Subject: DA2020/0915

DA2020/0915

4 Laura Street, Seaforth
Development Application No DA2020/0915
Proposed alterations and additions to an existing dwelling house

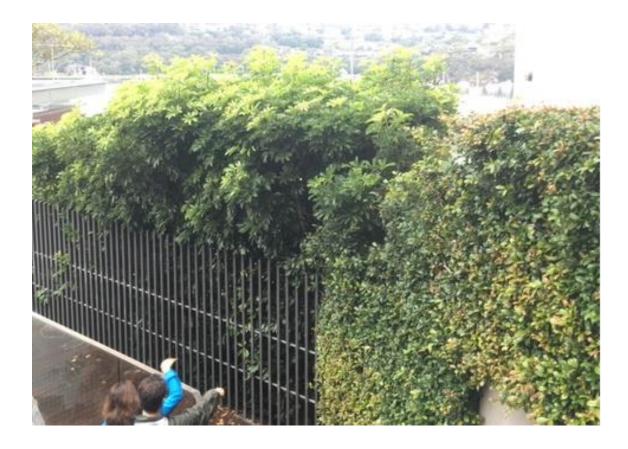
The new pool cabana will have solar access impacts on the kitchen and laundry areas at no 3 Laura Street. The combined kitchen/casual dining area is a key living area in the modern living, it is not a reasonable result when the new works are proposed within the required setback area and of significant height.

The solar access diagrams provided with the application state that there is no impact, but also show an increased 3pm shadow. It is not known how these shows will impact the eastern elevation of 3 Laura Street as inadequate details are provided. As stated earlier, the solar access impacts are the direct result of non-compliant works and this is an unsatisfactory result for the development.
